# Corrigendum for the Knee Measurements Locations

TEG-135  
 20 April 2010  
 JARI  
 (Information: from FTSS)

Figure 17: Flex-PLI; instrument locations

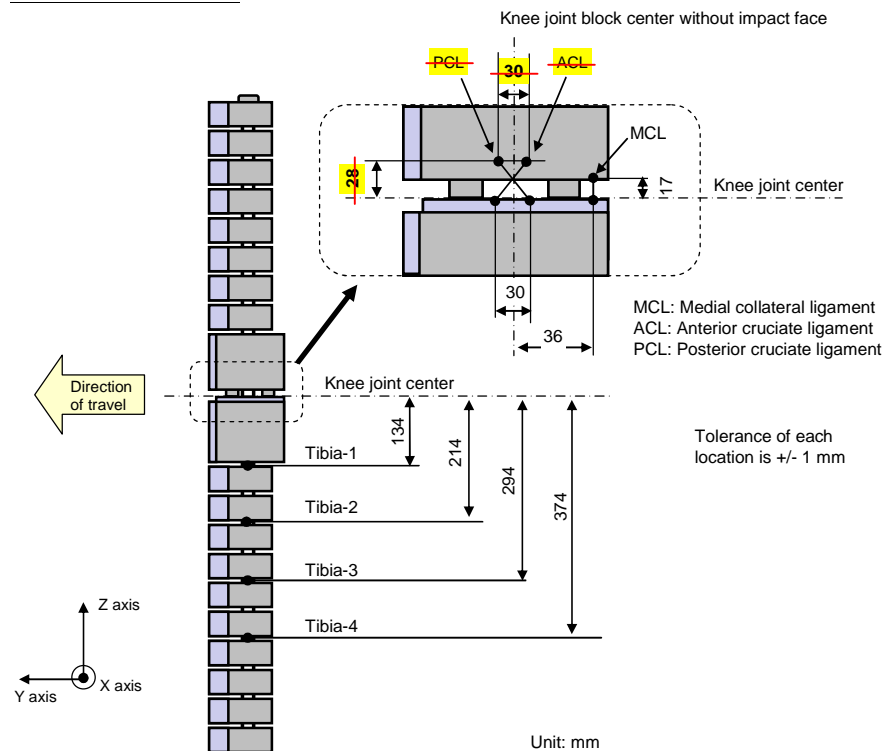
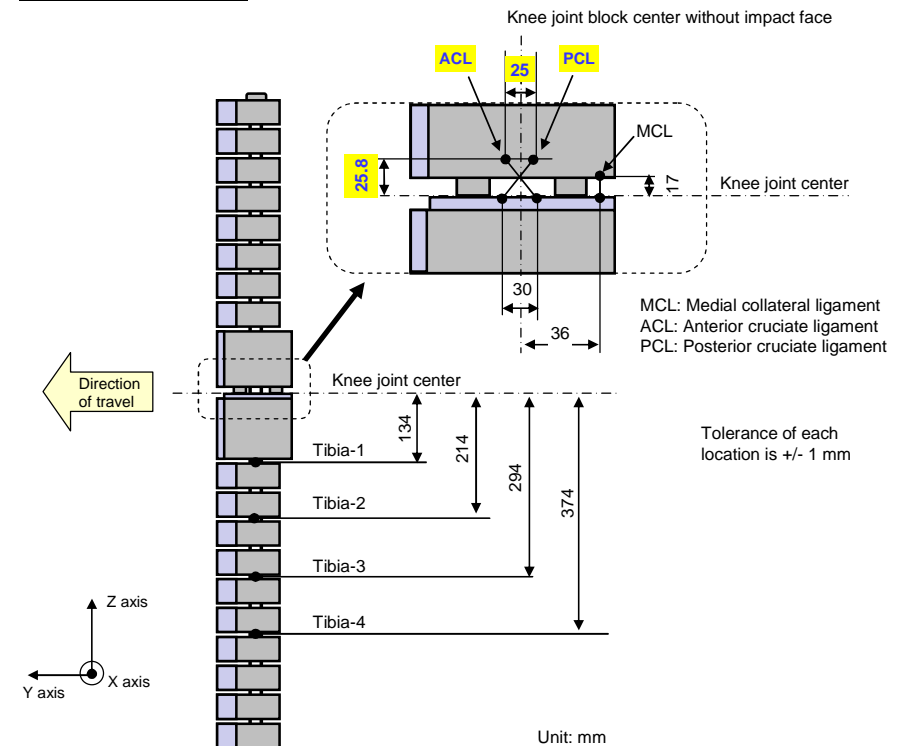
## Wrong Numbers

## Correct Numbers
